dsPIC33CK256MP508 Family Silicon Errata and Data Sheet Clarification

The dsPIC33CK256MP508 family devices that you have received conform functionally to the current Device Data Sheet (DS70005349K), except for the anomalies described in this document.

The following typographic corrections and clarifications are to be noted for the latest version of the device data sheet (DS70005349K):

FIGURE 1-1: I/O RAMP

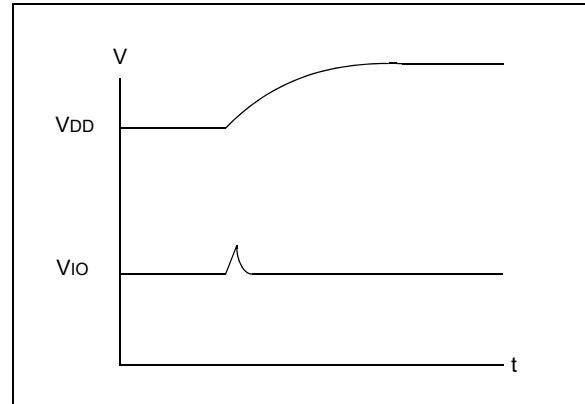
During a fast device power-up when the V_{DD} ramp is less than 4 mS, the I/O pins may drive up to 100 μ A current for a duration of up to 10 μ S (Figure 1-1).

1. Slow down the V_{DD} ramp time (greater than 4 mS for V_{DD} to ramp 0V to 3.3V).
2. Ensure the circuitry that is connected to the pins can endure this pulse.

Example applications affected may include complementary power switches, where a transient current shoot-through might occur. High-voltage applications with complementary switches should power the high-voltage 200 μ Sec later than powering the dsPIC[®] device to avoid the current shoot-through. This behavior is specific to each device and not affected by aging.
